UNITED STATES
DEPARTMENT OF THE INTERIOR
BUREAU OF LAND MANAGEMENT
APPLICATION FOR PERMIT TO DRILL OR REENTER

5. Lease Serial No. SF- 078194	
6. If Indian, Allottee or tribe Name	
7. If Unit or CA Agreement, Name and No	
8. Lease Name and Well No. Ludwick LS 17N	
9. API Well No. 30-045-34007	
1a. Type of Work: <input checked="" type="checkbox"/> DRILL <input type="checkbox"/> REENTER	10. Field and Pool, or Exploratory Basin Dakota & Blanco Mesaverde
1b. Type of Well: <input type="checkbox"/> Oil Well <input checked="" type="checkbox"/> Gas Well Gas <input type="checkbox"/> Other <input type="checkbox"/> Single Zone <input type="checkbox"/> Multiple Zone	11. Sec., T., R., M., or Blk. and survey or Area SECTION 29 T30N & R10W

The original APD was submitted on 10/11/2006. No approval was granted due to cactus at the original location. BP respectfully request permission to move the surface location from 2200' South & 1890' East to a new location suggested by the BLM.

DRILLING AND COMPLETION PROGRAM

PAD LAYOUT PLAN & PROFILE
BP AMERICA PRODUCTION COMPANY
 Ludwick LS #17N
 2300' F/SL 2155' F/EL
 SEC. 29, T30N, R10W, N.M.P.M.
 SAN JUAN COUNTY, NEW MEXICO

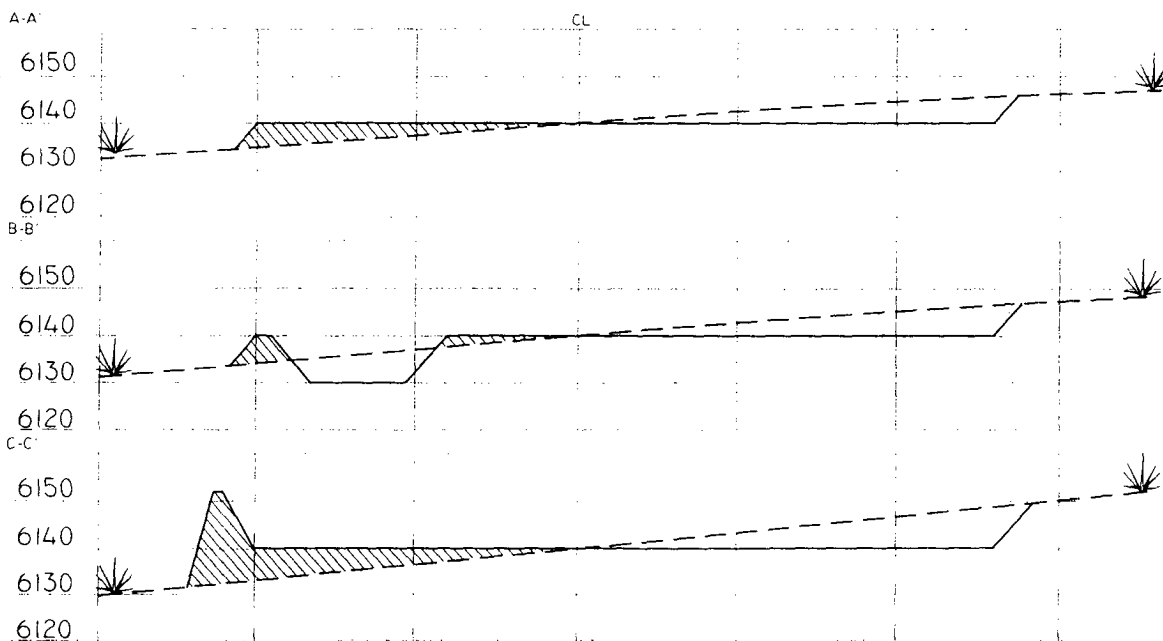
New Location: ^{FSL} 2300' South & ^{FEL} 2155' East.
